## DEVELOPMENT APPLICATION ASSESSMENT REPORT

| <b>Application Number:</b> | DA2022/1164 |

| <b>Proposed Development:</b>              | Demolition and construction of a commercial building   |

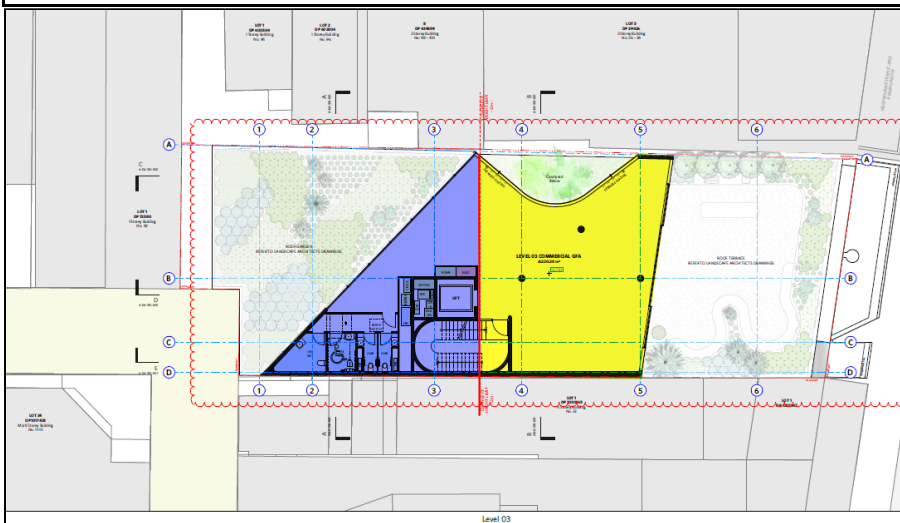
Image: Height limit control line (red) though mid section with rear 12m (blue) Level 3 floor space being partly above maximum height and at front 10m (yellow). Noted the corner balcony position of apartments behind in Rialto Lane shown Open terrace at front of proposed building is also above 10m height control.

Figure: Ground floor shows walk through link between Rialto Lane and the beachfront. The passageway has security gates / doors manage access hours and within the ground floor retail / commercial space (white) and food and beverage "back of house" areas are shown (blue). Vehicles

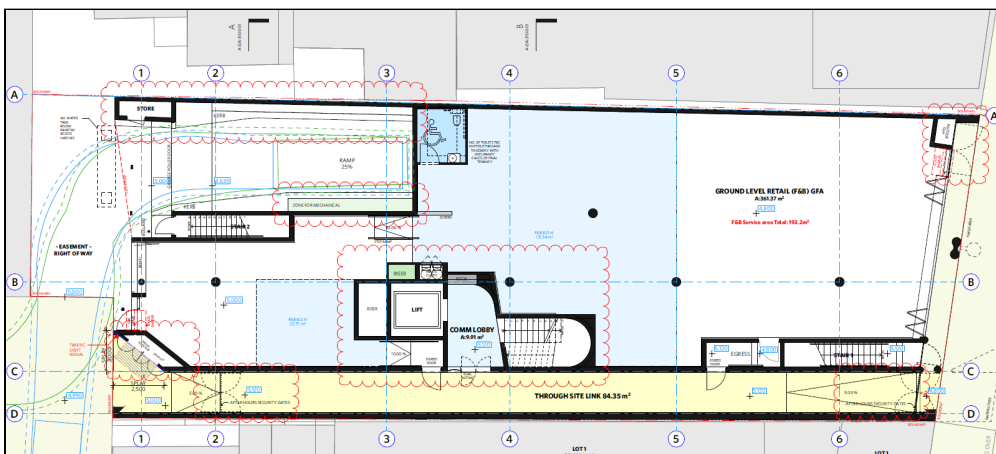
The proposal will maintain its active street frontage to Manly Beach front and South Steyne sidewalk with open plan ground floor area and a walk-through passageway that will connect to Rialto Lane. The passageway and rear frontage (to Rialto Lane) is open to assist activation of the laneway area. Generally services are concealed or confined to basement areas to encourage a more attractive laneway area. Conditions are recommended to enhance the rear (massed wall glazing) elevation to be more sympathetic to the current laneway appearances in Rialto Lane and other parts of the CBD Heritage Conservation Area, to include more traditional style fenestration window to masonry proportions and styling) and not a flat massed glass wall elevation (as shown).

access to the basement is via ramp along the right of way on the western (left) setback. The beachfront ground floor and lane openings have retractable shopfront door.

Figure: Upper basement level includes retail area, "end of trip" facilities for staff, services equipment space and carpark ramp access.

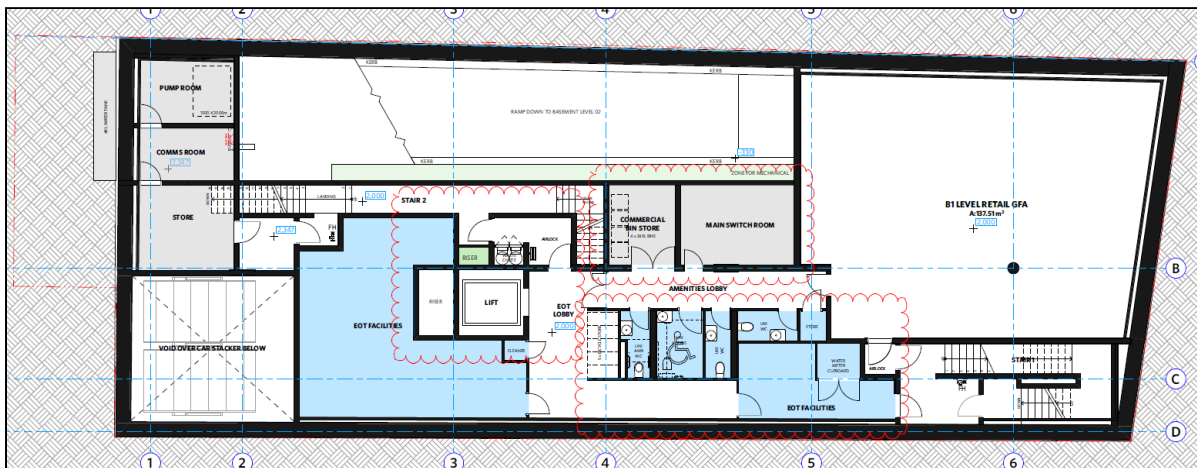
The zone however also restricts retail floor space on the land to less than 1,000sqm. In this case, the revised floor layout includes 137.51sqm retail in the basement (see image below) and 361.37 sqm at

ground level. (Total 498.88sqm).

The commercial floor space provided totals 1,292.18sqm which is 72% of the proposed building floor space (for use as commercial premises).

Image: South Steyne elevation appearance to adjacent buildings. Image: Rear (Rialto Lane) appearance and wall treatment.

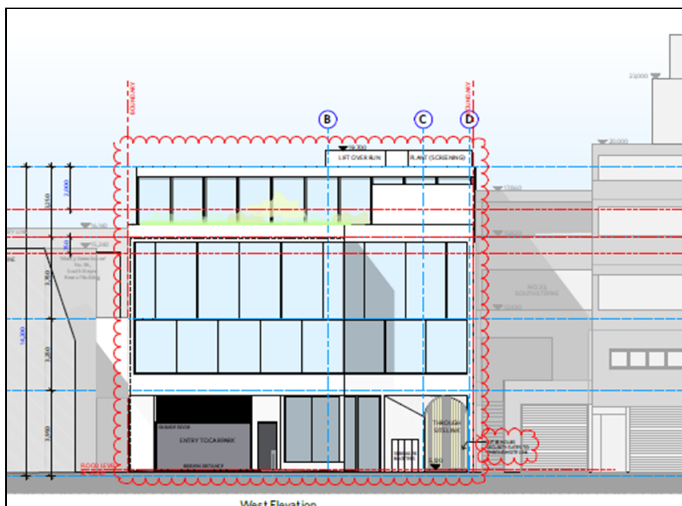
- The proposed upper level of the building is setback and has been amended to accommodate view lines without creating an unreasonable impact on the streetscape.

Having regard to the above assessment, it is concluded that the proposed development is consistent with the relevant objectives of MDCP and the objectives specified in section 1.3(a) of the Environmental Planning and Assessment Act, 1979. Accordingly, this assessment finds that the design is supported and subject to conditions has addressed previous concerns.
